LOCAL HISTORIC DISTRICT: Dilworth

PROPERTY ADDRESS: 814 East Boulevard

SUMMARY OF REQUEST: Addition

Charlotte Historic District Commission - Case 2012-071

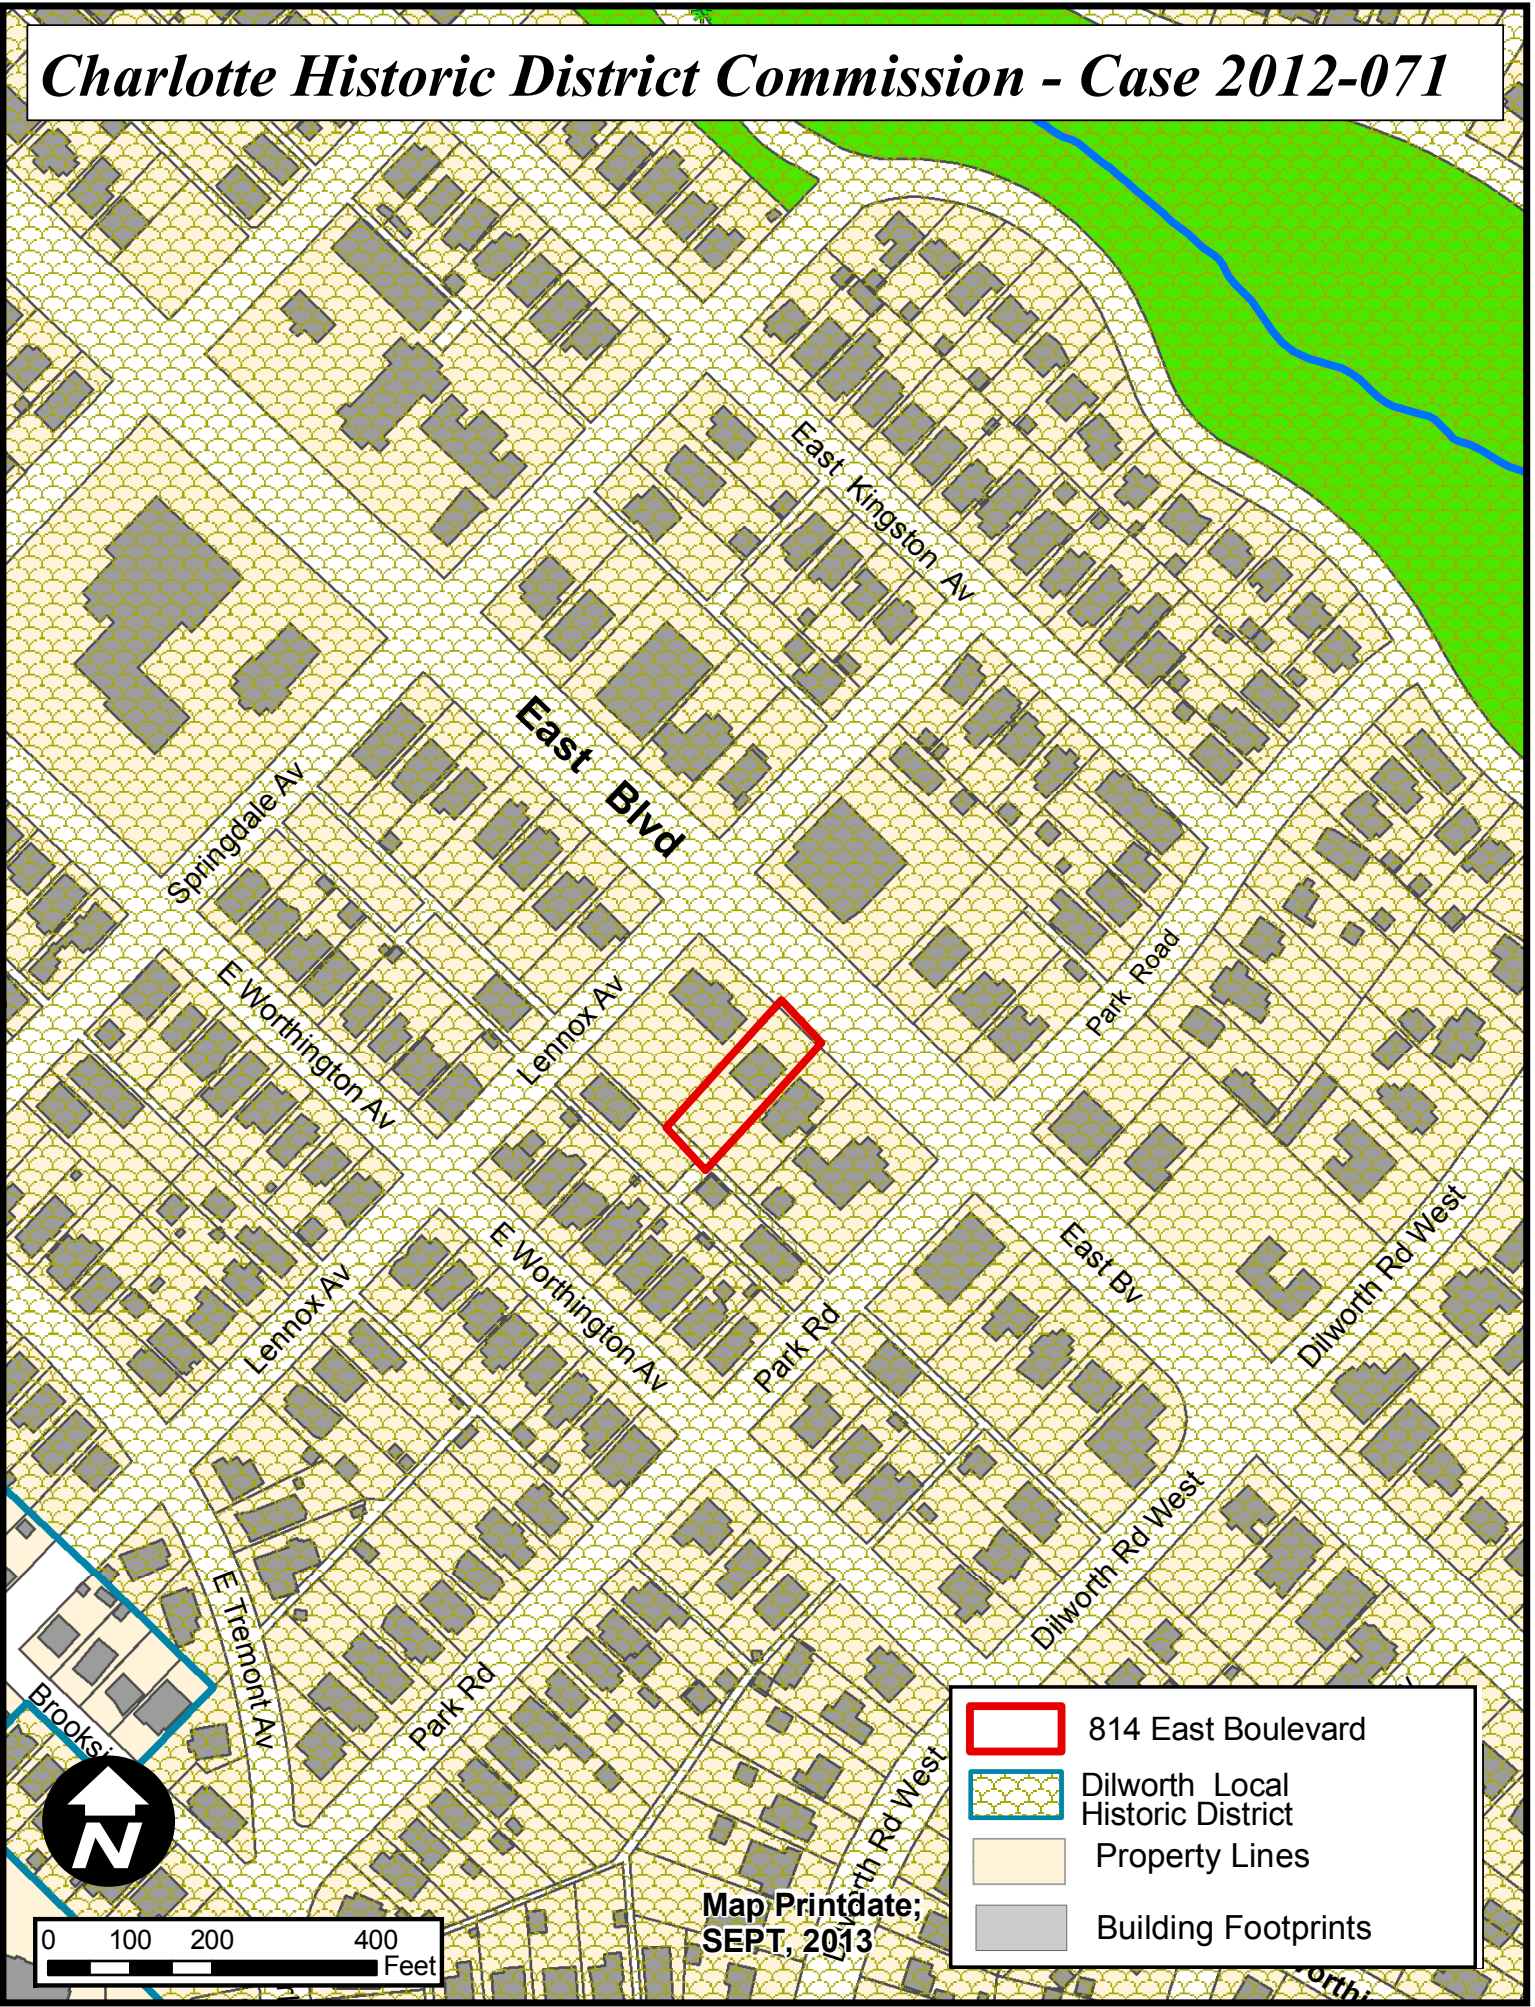
This proposal would extend the width of this existing building 8.5 feet to the left, as viewed from East Boulevard. It is in keeping with the overall architectural style of the house, and is not as wide front to back or as tall as the original structure. The addition is shown to match the house in detailing and materials, including the existing foundation, wood shake siding, windows, and window and eave trim.

There is also a small front facing shed dormer, as well as a similar rear facing dormer. The existing second floor fire escape stairs and the HVAC compressors will be relocated from this side to the rear as shown on the site plan.

Overall, the addition taken by itself appears to meet all relevant HDC design guidelines. The existing building does have a very symmetrical façade design, however, and that symmetry will be somewhat lost with this addition. At the same time, the addition is subordinate to the original structure, which does help offset this issue, and in a way in keeping with the Secretary of Interior's Standards for Historic Rehabilitation by being distinguishable from the original construction.

Left Side Elevation

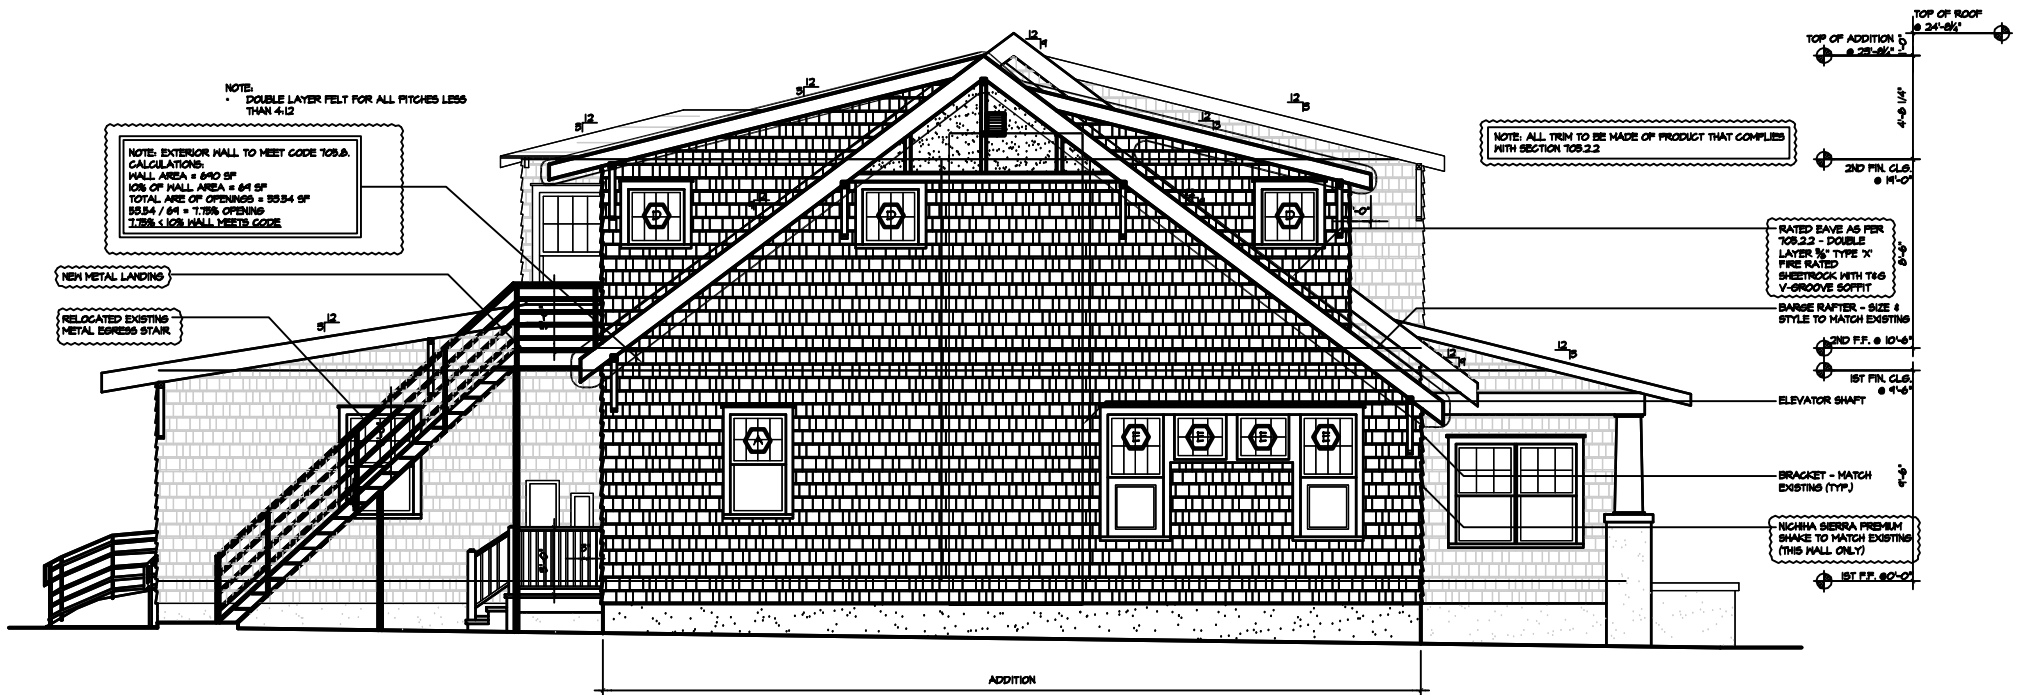
The project was reviewed by the HDC and approved in June 2012. In this case, the project was approved with cedar shake siding to match the existing façade as if it were a typical residential project. The plan reviewer for commercial projects noted the proposed siding material would not meet the fire rating requirement because of the building separation distance.

This application requests approval Nichiha siding in a cedar shake design on a portion of the left side elevation. The applicant is requesting an exception to the previous HDC approval by allowing a Non-Traditional Material based on commercial building code requirements that were unknown at the time of HDC review in 2012. The side elevation is not highly visible from the public street.

The Design Guidelines allow flexibility for material selection on a case by case basis. Though the building separation issue was not addressed initially it would remain a topic for discussion because of the commercial code conflicting with the Design Guidelines which are heavily based on residential construction. The type of material proposed has been common because of its resemblance to traditional materials. Based on the location of the addition, the type of siding being used and the uniqueness of this application staff believes the change in material is reasonable and within the intent of the Guidelines.
